NATIONAL FIRE PROTECTION ASSOCIATION

TO: Code-Making Panel 4

SUBJECT: NEC® CMP-4 Second Draft FINAL Ballot Results (A2025)

Figure Informational Note 690.1 Illustration of PV System ~~DC~~ dc Circuits and PV System Components in a Typical PV Installation.

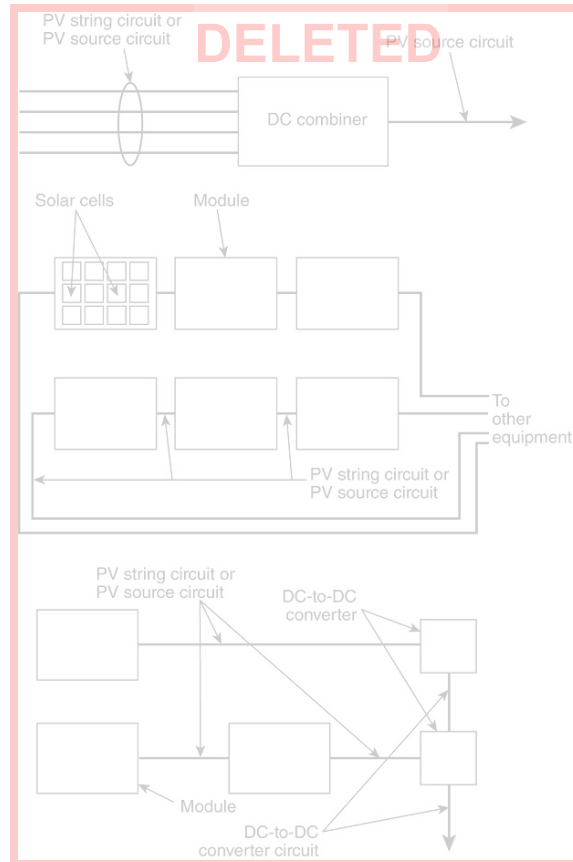
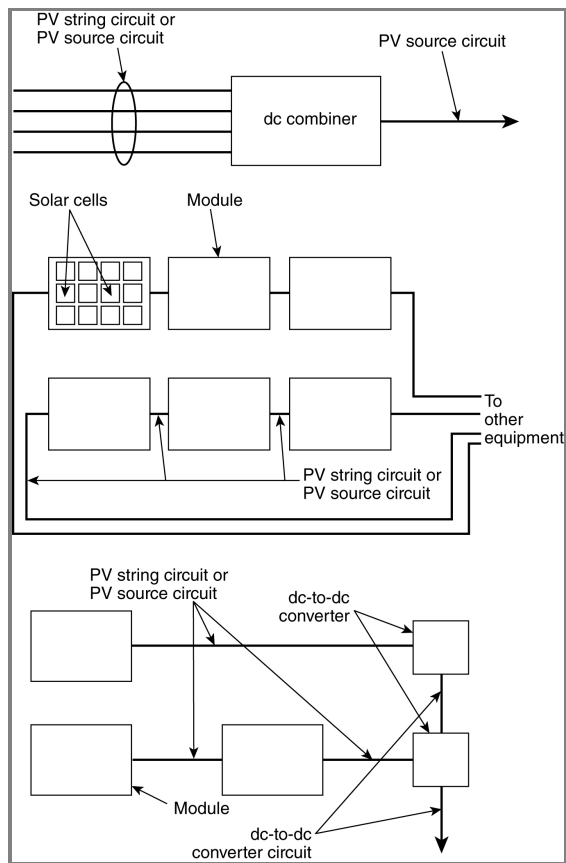
Should the "dc" at the beginning of the callout be capitalized (three places including "dc combiner")?
